Subject: Project name BROOKE RES. ACCESSORY BLDG.
 Project site address 12419 ALL DAUGHTERS LANE
 Permit # B23000244 SDP # _____
 Other information pertinent to this project _____

Permit No: B23000244
Project Name: Brooke – Residential Accessory Structure

Per previous submittal our variance was denied. This resubmission reduces the footprint, removes the mezzanine, and restroom.

Job	Truss	Truss Type	Qty	Ply
Q-90266H	T1S	SCISSORS	18	1

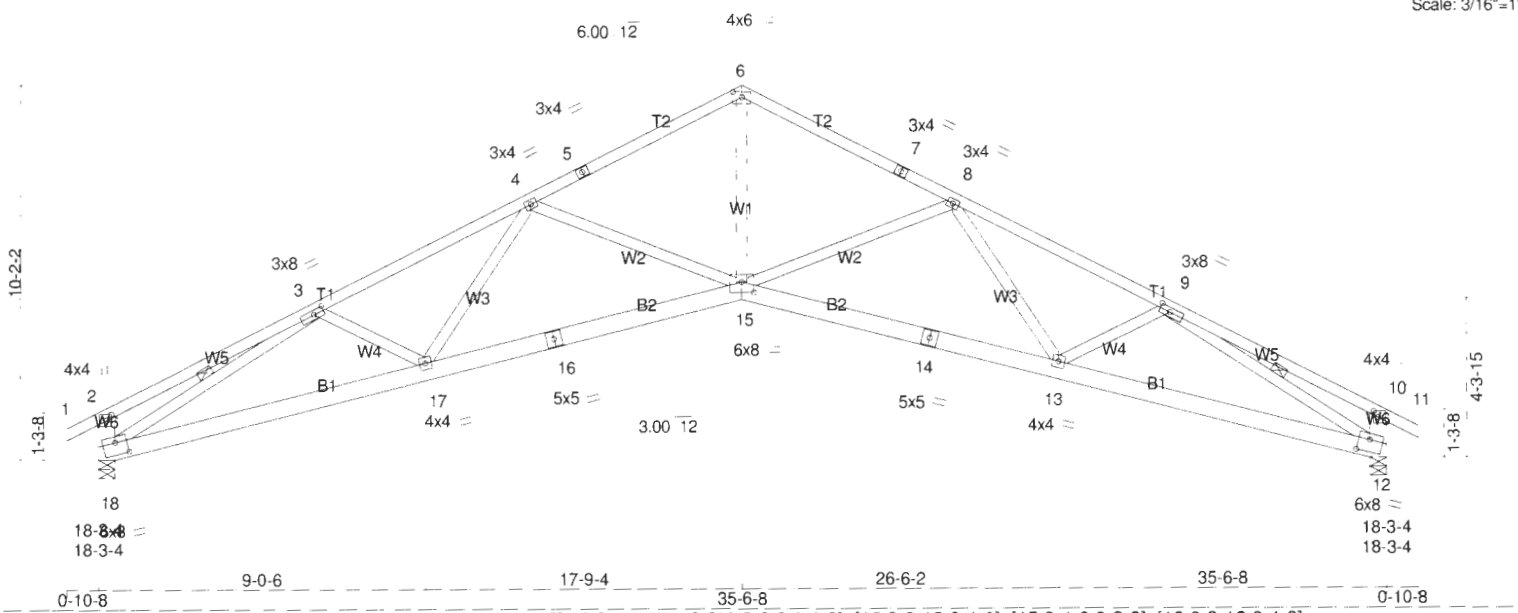
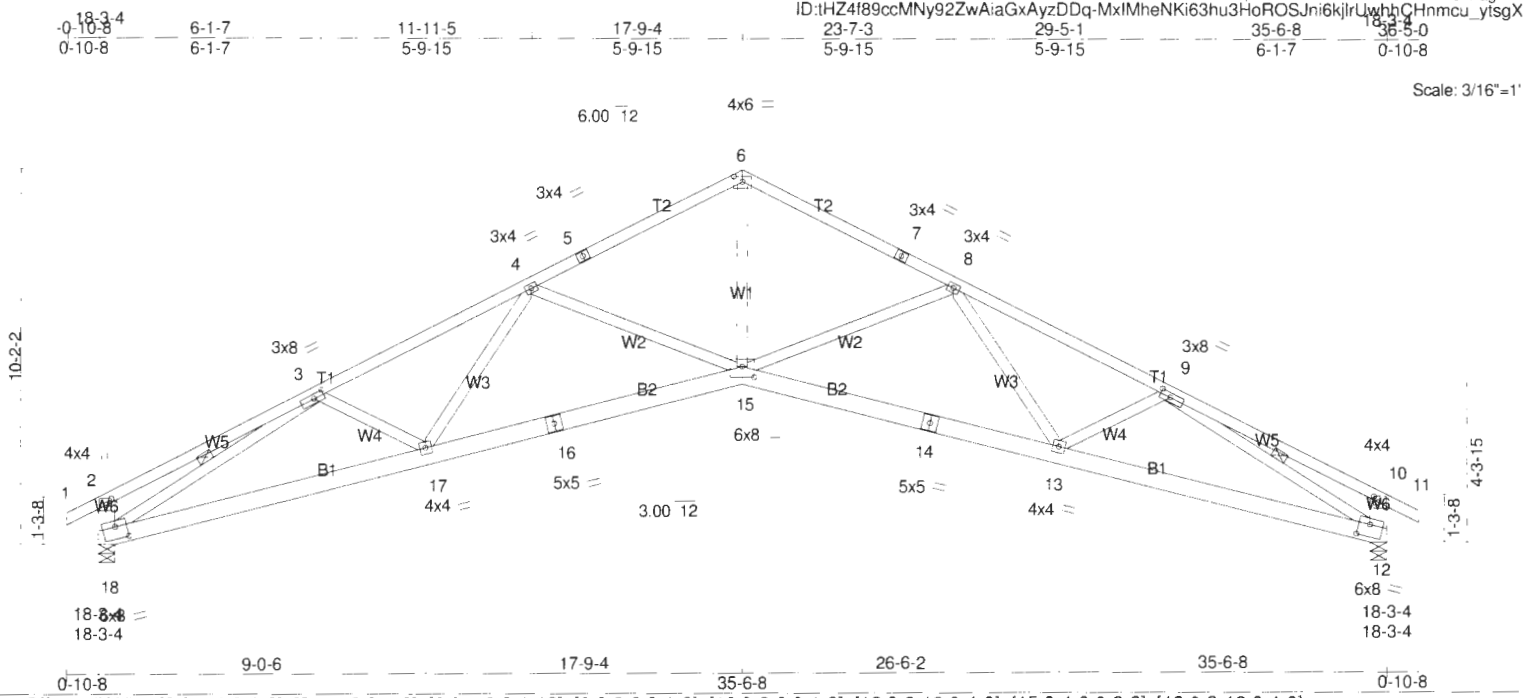
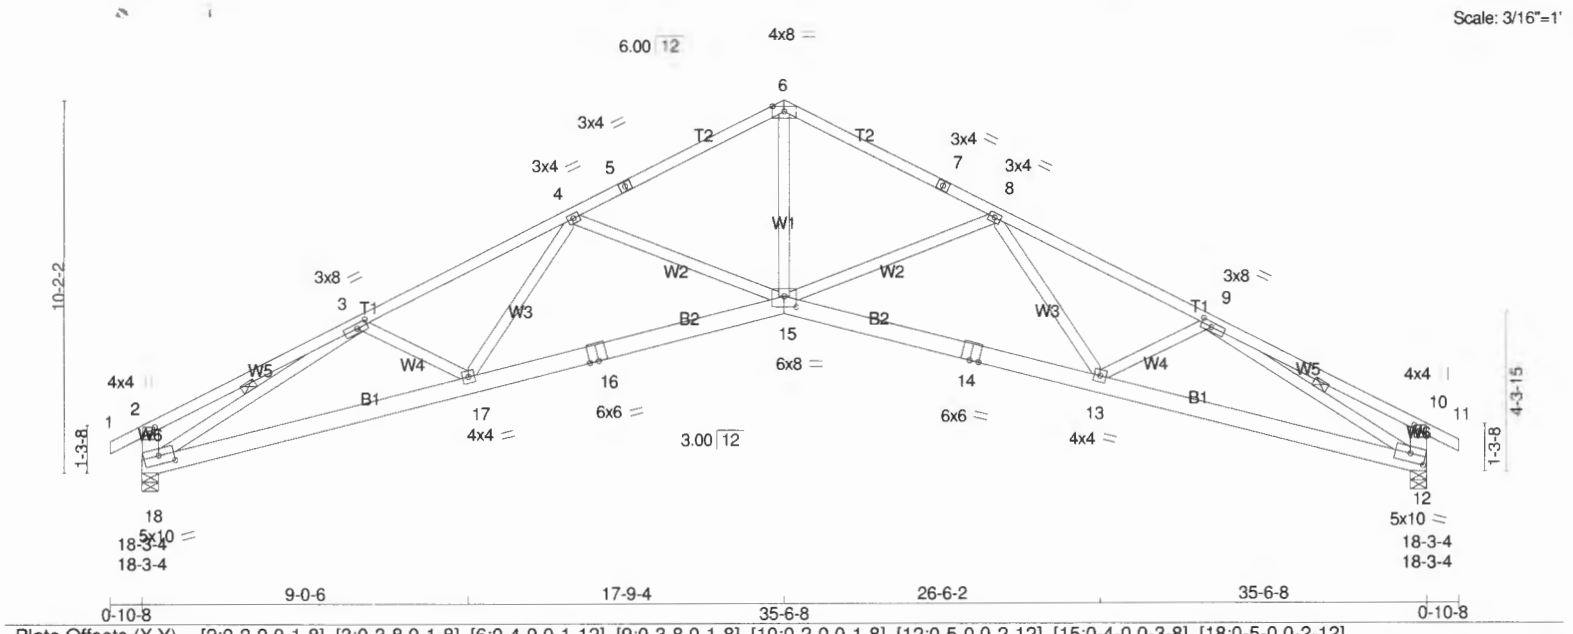
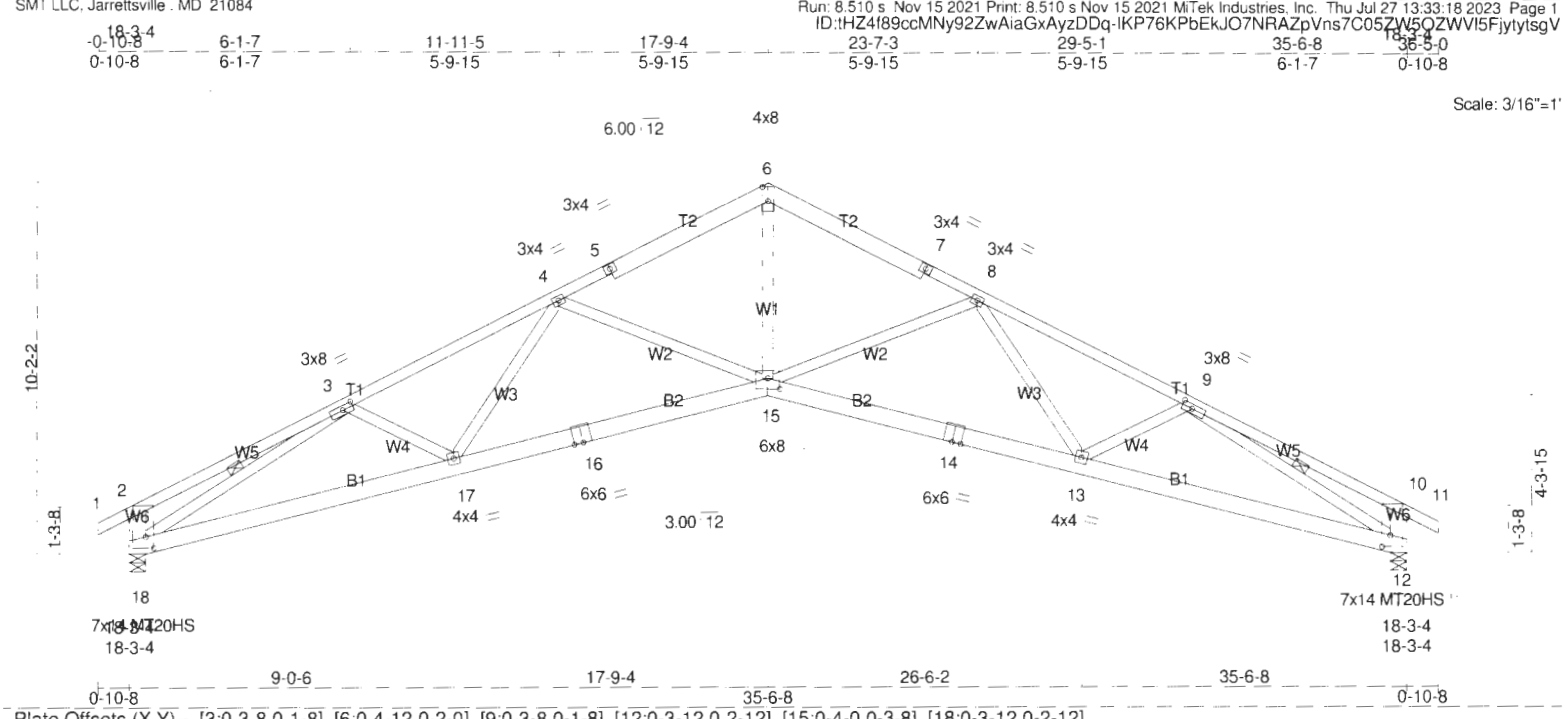
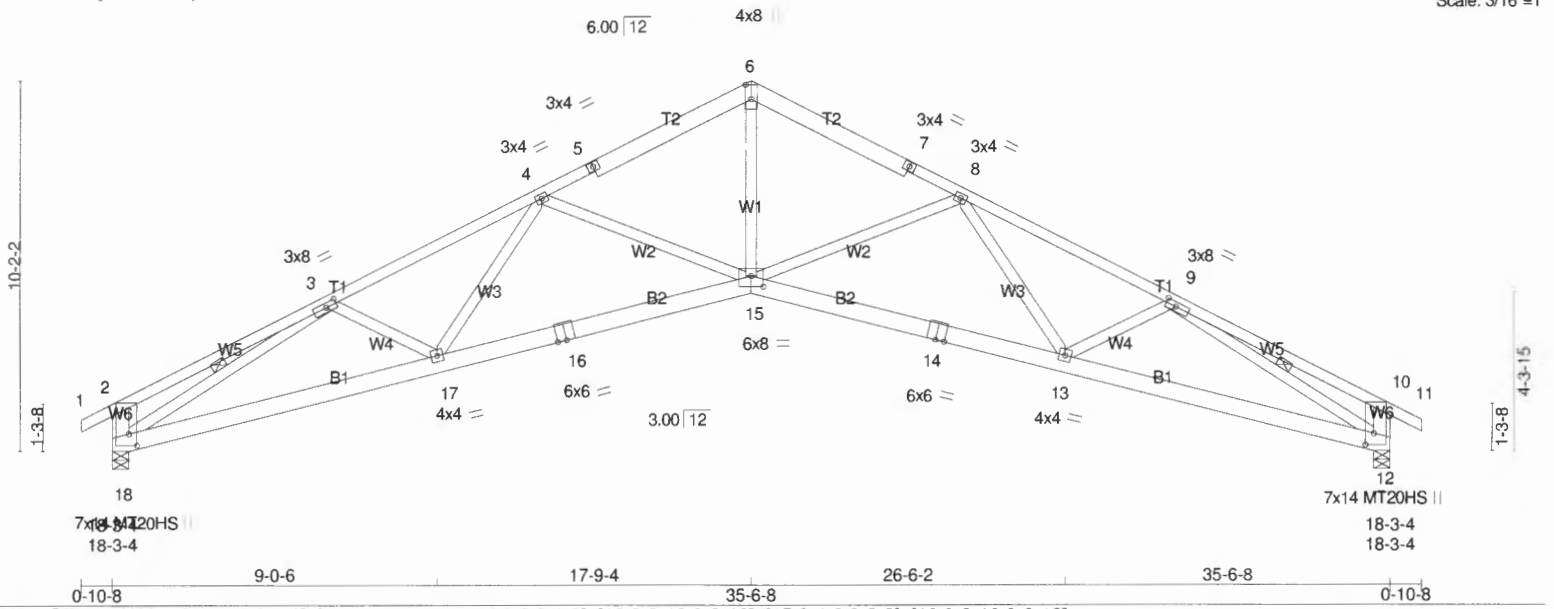
1. *How will bathroom meet 2018 IECC Insulation requirements, how will it be heated to prevent freezing pipes?*
 - a. The bathroom has been removed.
 2. *Structural drawings say Engineers stamp is void unless green seal is present, no green seal.*
 - a. Green seal removed.
 3. Roof trusses should be designed for 40psf ground snow load per Howard County Amendment.
 - a. Roof Truss engineering drawings have been attached showing snow load of 40psf.
-

PLOT PLAN

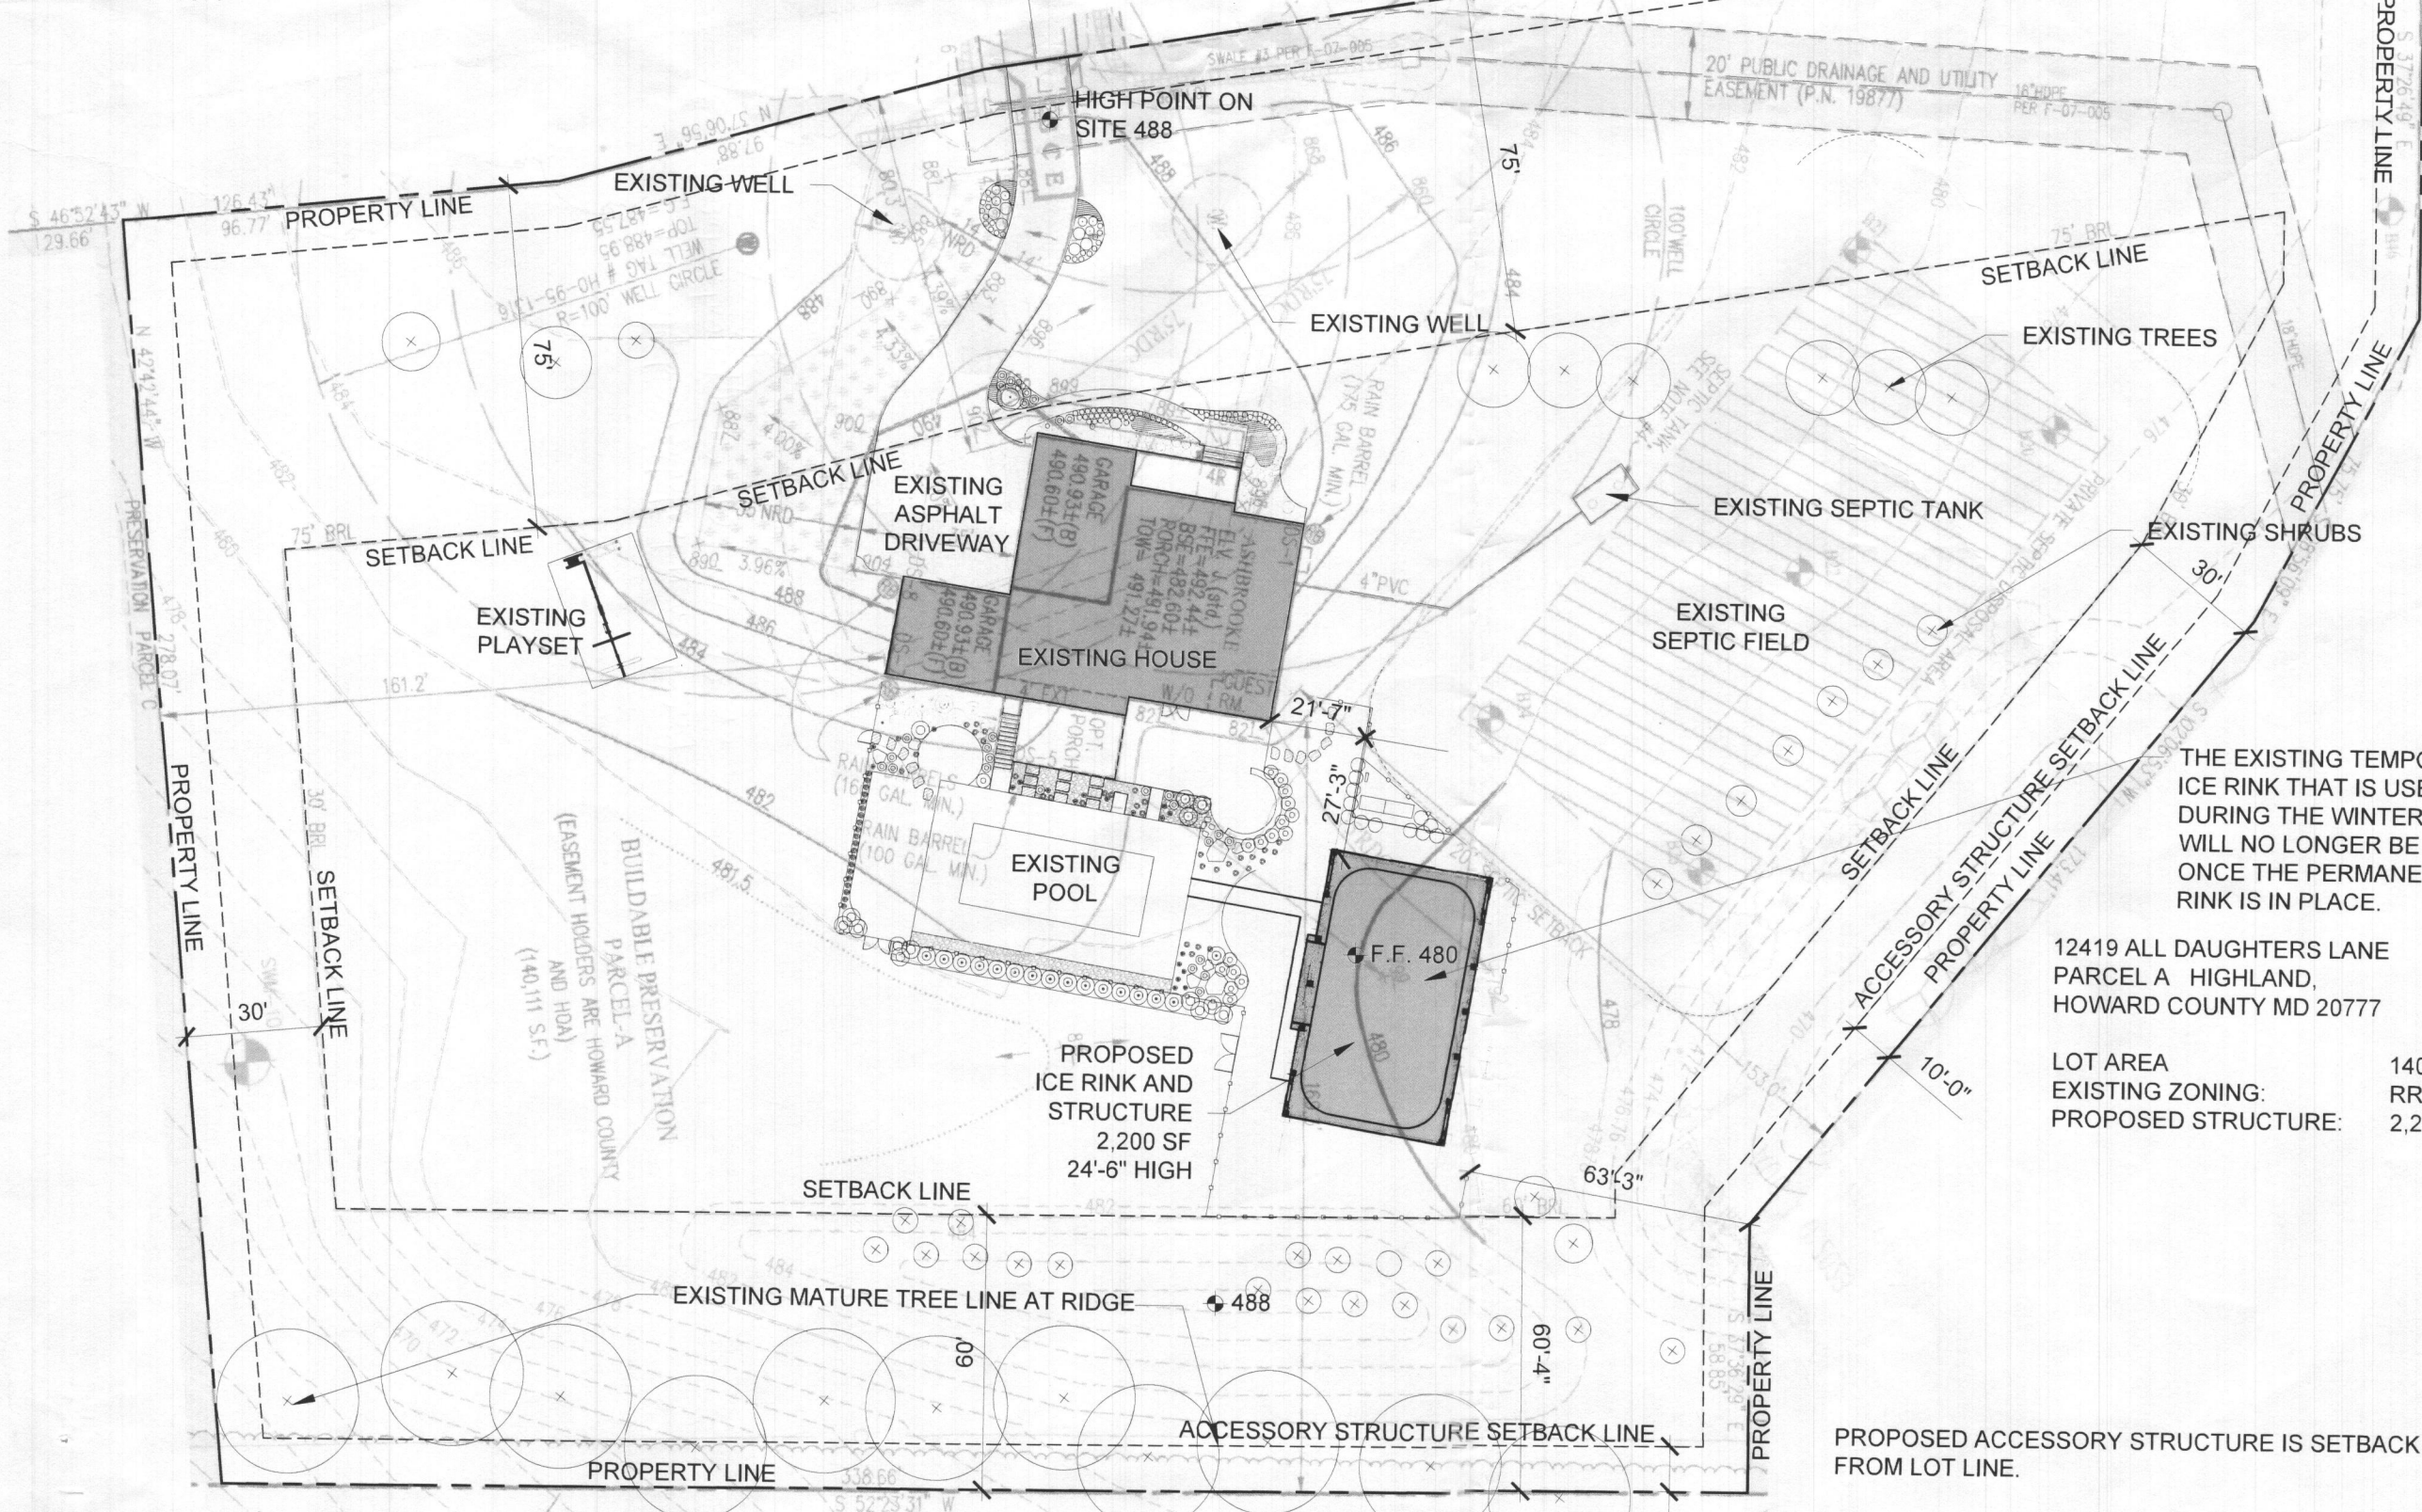
1. *Need to show the septic drain fields on the plot plan. There is a "septic as-built drawing from 2019" that needs to be referenced and transposed onto the current large-scaled plot plan. It appears that the drain fields go beyond the sewage disposal area. - ZS*
 - a. We have referenced and transposed the existing septic drain fields based on the as-built drawing onto the large scale site plan.
